STB-0107 – Brow Light Bracket Updates

With the implementation of NFPA 1900, Sutphen has been required to update our brow light bracket designs. Through prototyping and testing with our vendor partners, Sutphen will be able to offer brow lights in compliance with NFPA standards while minimizing the impact to customers.

Figure 3 & 4: New FRC Spectra Brow Light Bracket (will not have Sutphen logo cutout)

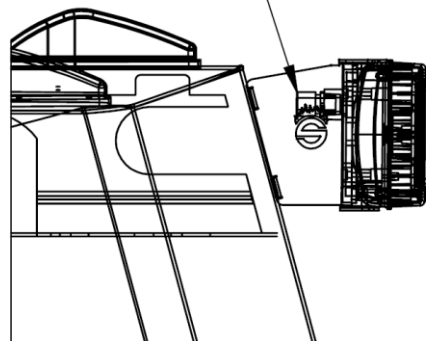
NFPA 1900 10.9.10.2.4 states, “Any scene lights shall be mounted in a way that they do not block the DOT clearance or identification lights on the cab or body.”

The new brackets designed for Sutphen will mount the brow lights lower on the front face of the cab. This lower mounting position will not block the three, centered clearance lights on top of the cab roof, as mandated by NFPA 1900.

Below are photos and drawings of the new brackets from Whelen and FRC. Please be advised that with the new mounting locations being lower than previous designs, the new brackets may affect customer’s graphic packages. This includes lettering and/or graphics items in the area above the front windshields.

strain relief for rear cable exit
as currently done now
